ATAG's Concerns With Section 10.4

Issue 1: The 20% tree canopy requirement for one-family development is at risk

Proposed Section 10.4.6.E - On-site Trees:

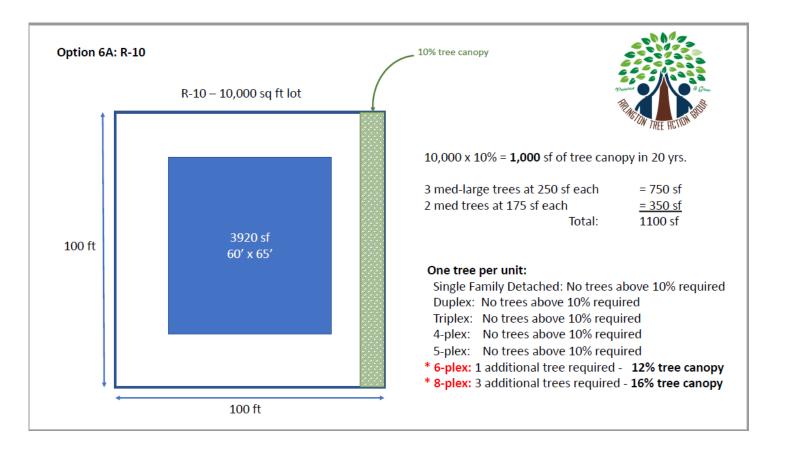
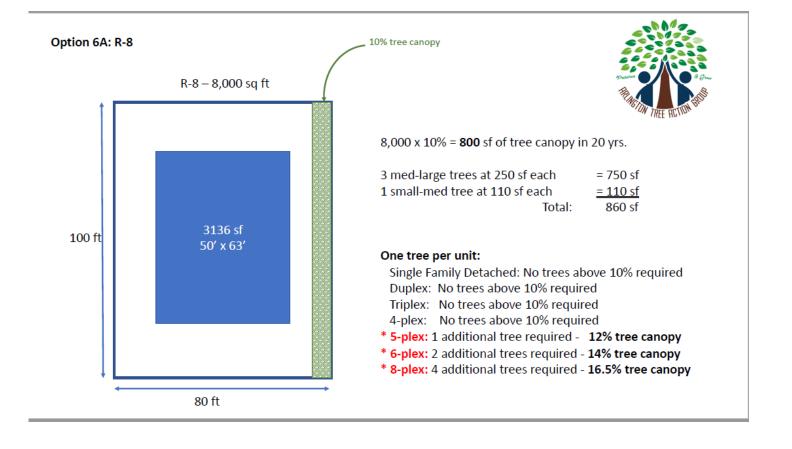
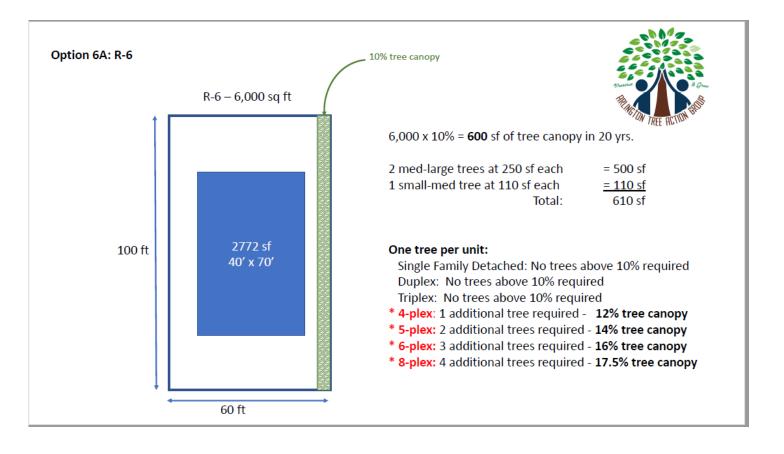
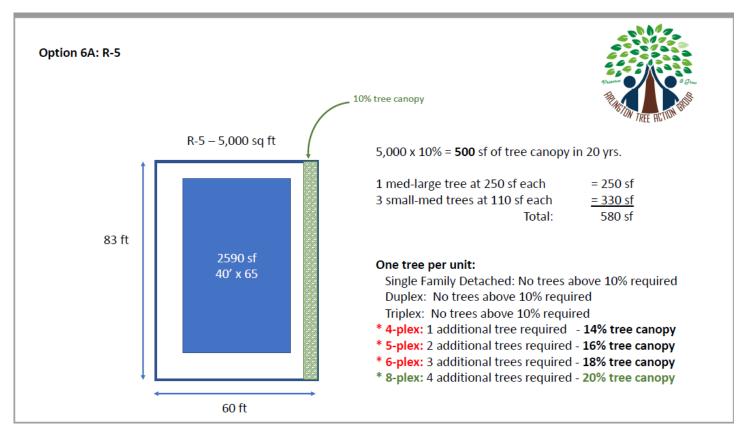
Issue 2: The "one tree per unit" policy results in fewer trees than the current 20% minimum for single family detached.

"Depending on the specific development proposal (e.g., number of dwellings, site area, tree species), Option 6A would <u>generally result</u> in tree canopy coverage that is <u>closer to parity</u> with the CBPO requirement for one-family development."

THIS STATEMENT IS INACCURATE.
